COUNCIL ASSESSMENT REPORT

SYDNEY CENTRAL CITY PLANNING PANEL

PANEL REFERENCE & DA NUMBER	PPSSCC-448 - DA 318/2021/JP/B
PROPOSAL	Section 4.55(2) Modification to an Approved Residential Flat Building Comprising 33 Units under the Provision of the SEPP Affordable Rental Housing 2009
ADDRESS	Lot 11 DP 280013 1-28/40 Civic Way Rouse Hill
APPLICANT	Link Wentworth Housing Limited
OWNER	Link Wentworth Housing Limited
DA LODGEMENT DATE	22 May 2023
APPLICATION TYPE	Development Application
REGIONALLY SIGNIFICANT CRITERIA	Part 2.4 and Schedule 6 of SEPP Planning Systems 2021
CIV	\$12,572,764 (excluding GST)
CLAUSE 4.6 REQUESTS	NA
KEY SEPP/LEP	SEPP Housing 2021 SEPP No. 65 - Design Quality of Residential Apartment Development Local Environmental Plan 2019
TOTAL & UNIQUE SUBMISSIONS KEY ISSUES IN SUBMISSIONS	Nil
DOCUMENTS SUBMITTED FOR CONSIDERATION	Architectural Plans – Stanton Dahl Architects Statement of Environmental Effects – Creative Planning Solutions Amended Waste Management Plan – Dickens Solutions BCA Capability Statement - Concise Certification Fire Engineering Services – Holmes Australia CIV Estimate Report - MBM

ATTACHMENT E: PROPOSED BASEMENT PLAN

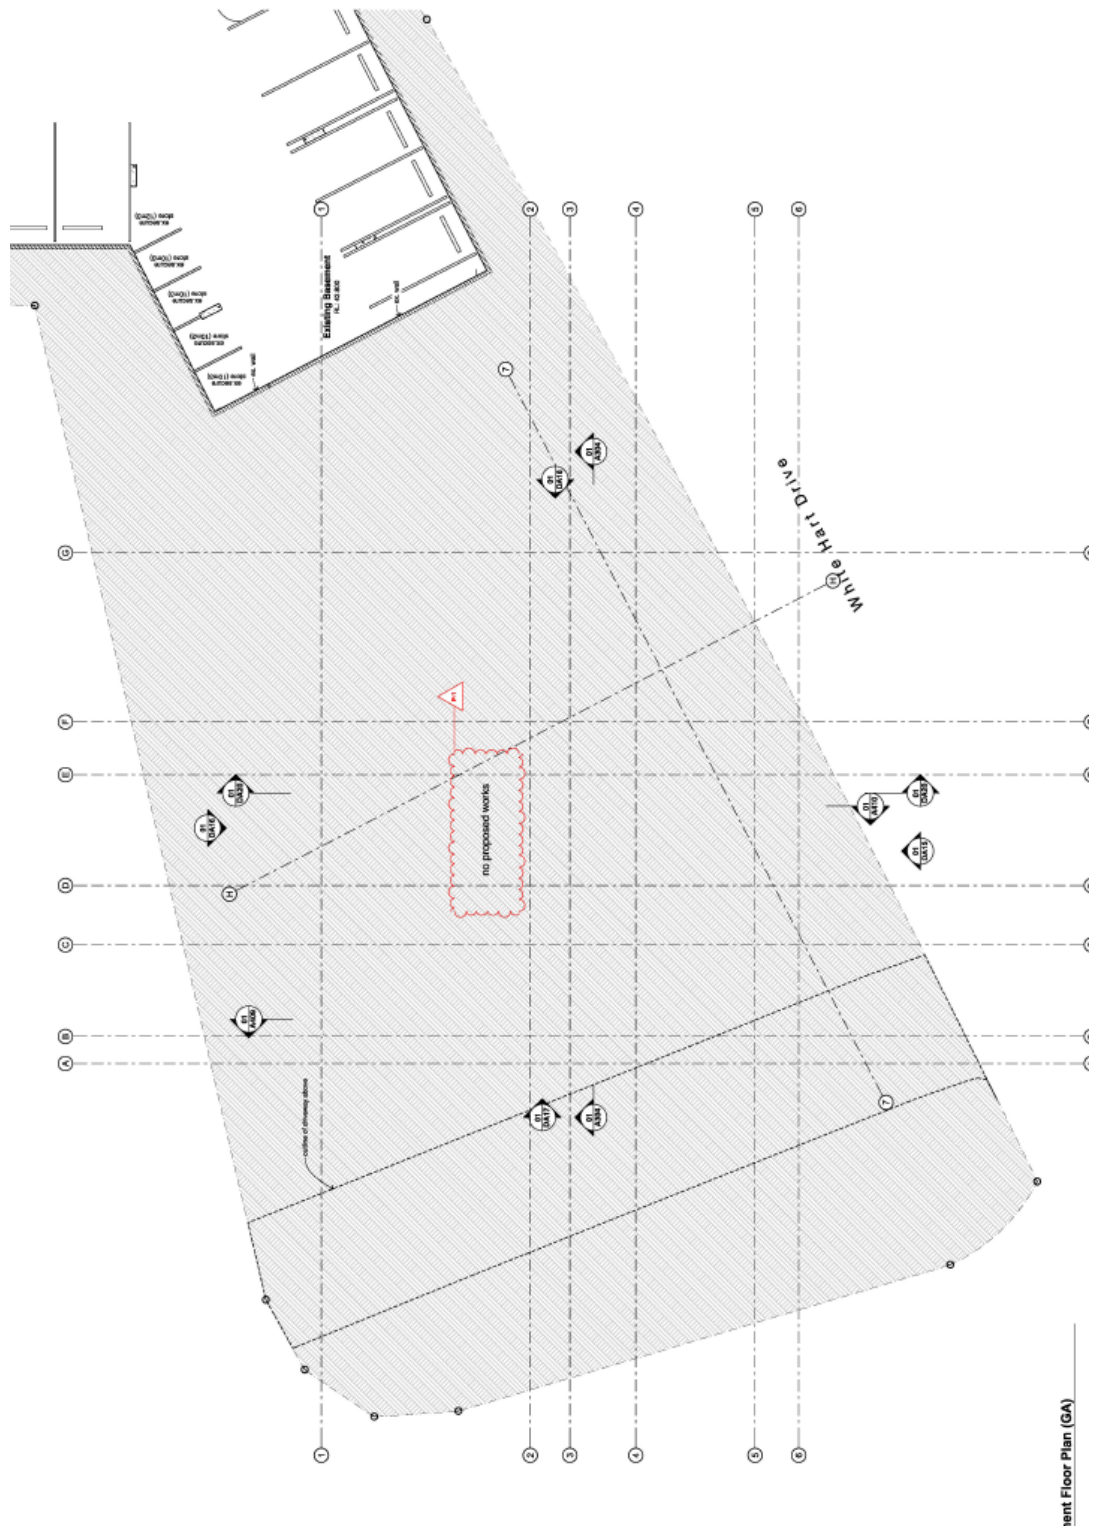
The proposed modification application seeks to delete the approved basement connection link which was approved between the existing basement car parking and which contained a waste storage area and underground connection between the existing and approved buildings. In addition, the existing at-grade waste storage area will be expanded to cater for both the existing and approved building and landscape works on the ground level will be amended. In regard to the proposed modification, the applicant has requested that Condition 7 be deleted.

As building works are proposed to the existing bin storage area which is built over the external wall of the existing basement, Section 64 of the EP & A Regulation still has context to the existing building. As there are inadequate measures to assist occupants egressing the building and inadequate measures to restrict fire spread, conditions can still be imposed for some level of upgrade to the existing building. It would be onerous for Council to require a suppressions system to be installed where only minor building works are being undertaken. Works to the existing hydrant system/service penetrations would still be recommended to remain in the consent, and as such Condition 7 cannot be deleted, but is recommended to be modified.

7. Clause 94 Upgrading

Under clause 94 of the Environmental Planning & Assessment Regulation, the following fire safety/Building Code of Australia (BCA) works are to be undertaken with the construction certificate works and are to be completed prior to the issue of the occupation certificate:

ATTACHMENT H: PROPOSED GARBAGE ROOM PERSPECTIVE AND ELEVATION

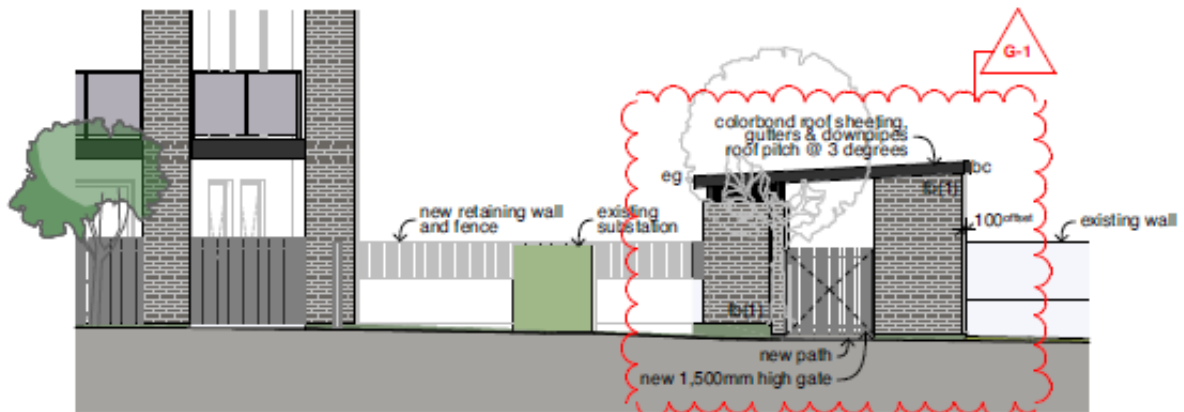
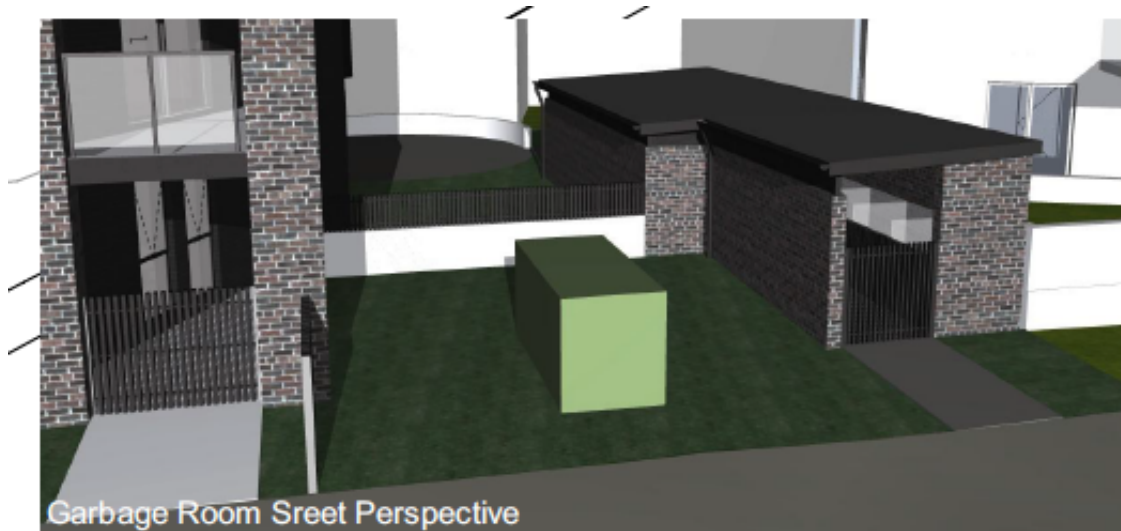
In respect the waste management, the current arrangement is that garbage bins are collected from White Hart Drive and recycling bins are moved to the Town Centre loading dock opposite for collection. As part of the current application, the waste collection arrangements will be rationalised to allow all collection from White Hart Drive, with the waste truck driver moving the bins in and out of the garbage bay. In addition, the new bin area will also make provision for bins for food organics garden organics. Condition 57 relating to procurement of a mechanical bin mover and Condition 68 relating to bin presentation for waste collection in the Town Centre loading dock are also recommended to be deleted given that collection will be from White Hart Drive.

Construction of Waste Storage Area

The waste storage area must be designed and constructed in accordance with the following requirements. The area must provide minimum storage facility for a total of 14 x 1100 litre bins (7 x 1100 litre garbage and 7 x 1100 litre recycle bins) and 4 x 240 litre bins (food organics garden organics).
